**Federal Aviation
Administration**

FAA Initiative to Address Noise Concerns of Santa Cruz/Santa Clara/San Mateo/San Francisco Counties

UPDATE ON PHASE TWO

November 2017

Figure A1: Comparison of Golden Gate arrivals (May 2014) and BDEGA arrivals (May 2016)

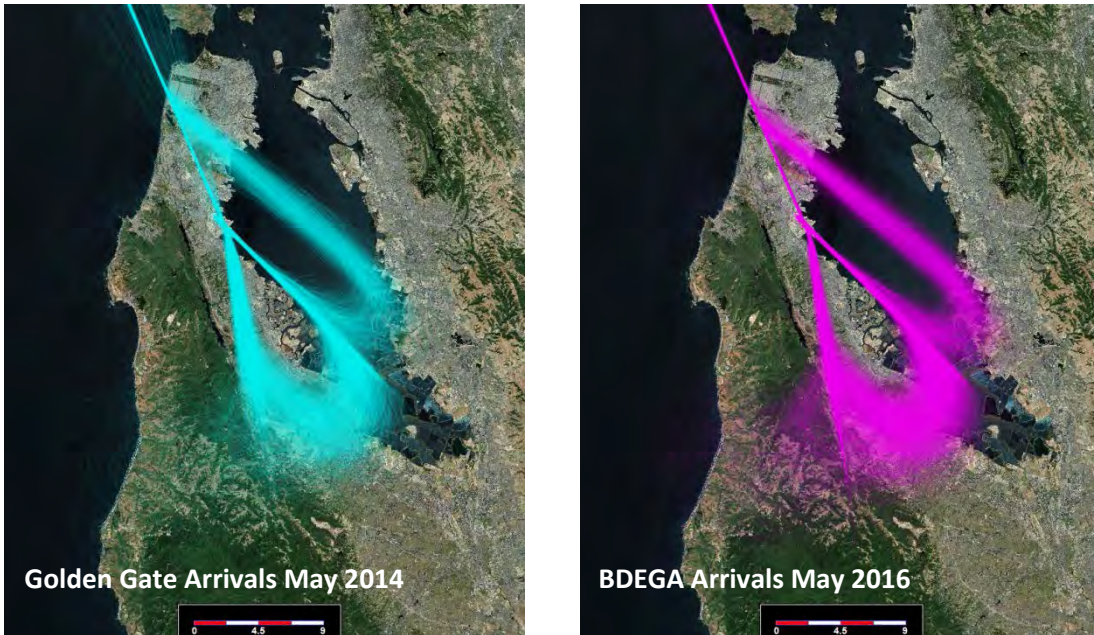
2.4 The FAA provide data on Golden Gate/BDEGA lateral track locations pre-NextGen and post-NextGen and if new procedures can use headings, not tracks, in procedure design.

The FAA reviewed the identified arrivals: the Golden Gate and BDEGA arrivals. The Golden Gate arrival states, “...via SFO R-303 to SFO VOR/DME. Expect RADAR vectors to final approach course.” Aircraft that flew this arrival navigated to the SFO VOR/DME via the SFO 303° radial, which is a conventional, or non-precision, method of navigation. Upon reaching the SFO VOR/DME, aircraft on the Golden Gate arrival were typically instructed to fly a 140° heading. Note, the Golden Gate arrival does not stipulate a 140° heading.

Therefore, aircraft that historically flew the Golden Gate arrival and that currently fly the BDEGA arrival essentially perform the same maneuver after crossing SFO/DME / BRIXX. Figure A1 (above), a review of one month of Golden Gate arrival aircraft (Teal) and one month of BDEGA arrival aircraft (Pink), supports this conclusion.

Figure A2: SEPDY Reporting Point relative to SSTIK waypoint.

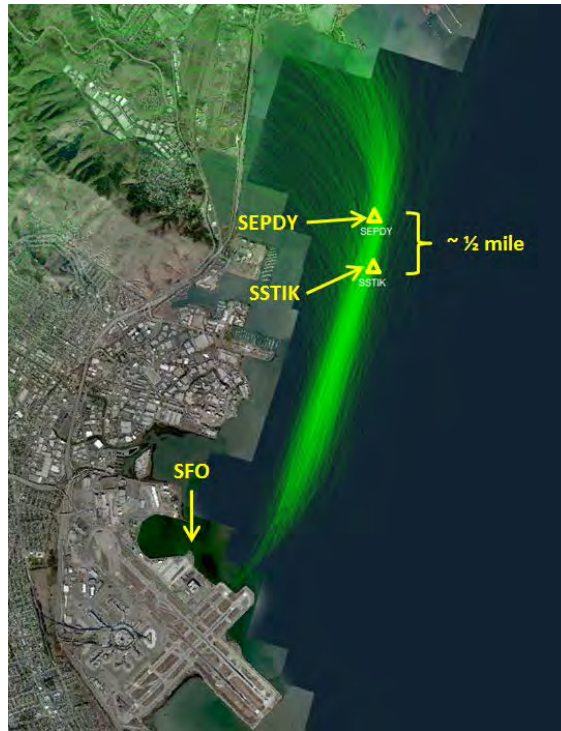
2.37 SSTIK: Avoid non-safety vectoring prior to SEPDY waypoint.

SEPDY is a reporting point from the conventional PORTE and OFFSHORE departure procedures. The SSTIK RNAV departure, which serves as PORTE and OFFSHORE's replacement for nearly all southbound aircraft, does not include the SEPDY reporting point. While not a part of the SSTIK departure procedure, the point in space that is SEPDY already sees the majority of SSTIK departures passing through it, as illustrated above in Figure A2.

Figure D1: Intercept FAC below the glideslope

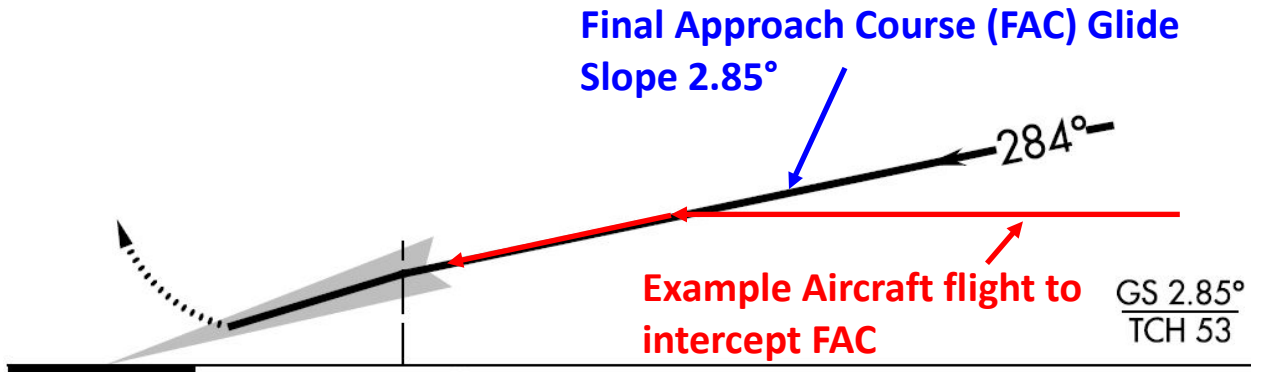
1.21 All air traffic in the vicinity of the MENLO waypoint (including vectored traffic from other procedures) be kept at altitudes of 5,000 feet or higher, even if not crossing directly over the MENLO waypoint.

The average altitude of vectored traffic in the vicinity of MENLO waypoint is approximately 4,600 feet MSL. Aircraft that fly in the vicinity of MENLO with the intention of landing on Runways 28L or 28R at SFO are subject to the same descent requirements of those that cross MENLO on an arrival. Those requirements are detailed in the FAA's NorCal Phase One Report, 1.a.i. and Appendix D. For safety considerations, and to fly a stabilized approach, aircraft must be descended in order to intercept (join) the Final Approach Course (FAC) at or below the glideslope (See Figure D1).

Figure D5: Graphical Depiction of Routes

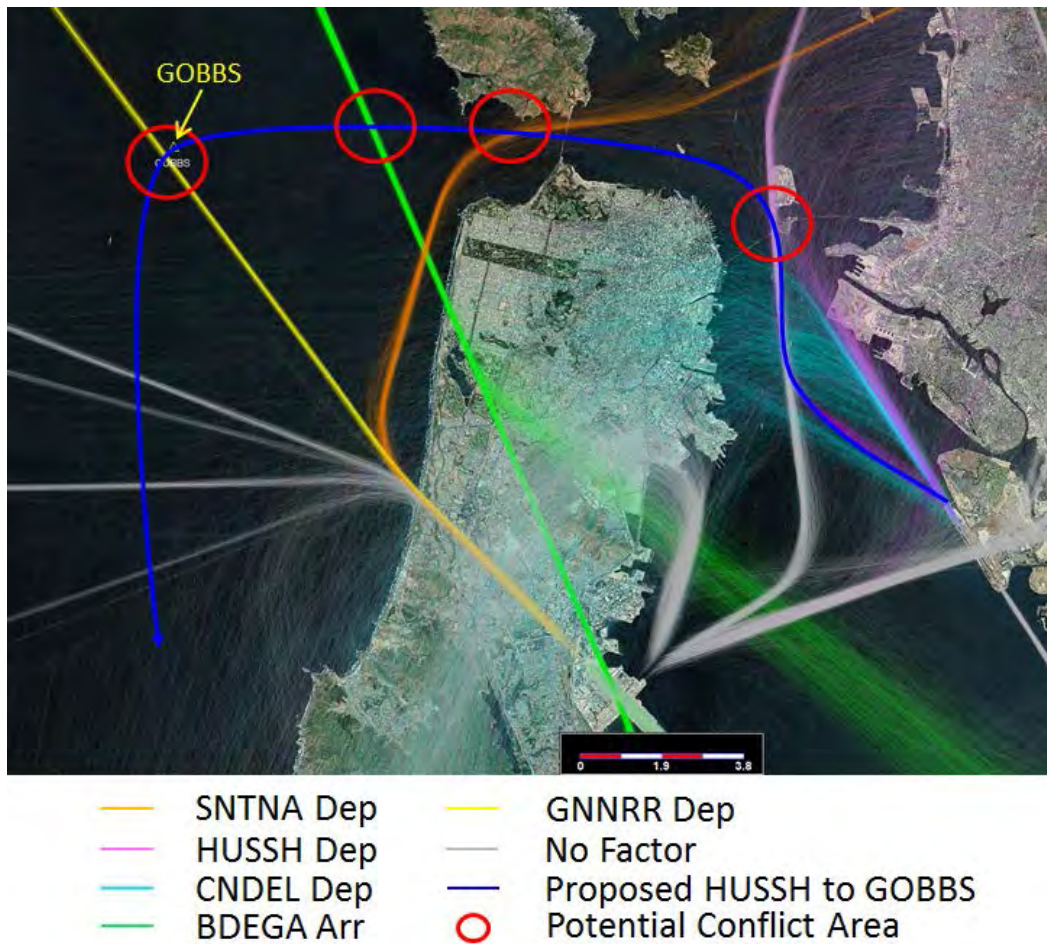
2.31 Determine if a revised southbound transition (with additional waypoints) for the CNDEL procedure could “contain” the flight paths further west (GOBBS and south) to allow expanded clear space for possible modification of the SSTIK departure.

In the above image (Figure D5), the teal tracks represent current CNDEL departures, while the pink tracks represent current HUSSH departures. The blue line approximates the FAA’s understanding of the Roundtable’s recommendation – that the CNDEL departures (teal), a day and nighttime departure procedure, be routed on a track approximating the blue line to GOBBS, then South. CNDEL, as it is published today, is designed to be laterally separated from SSTIK
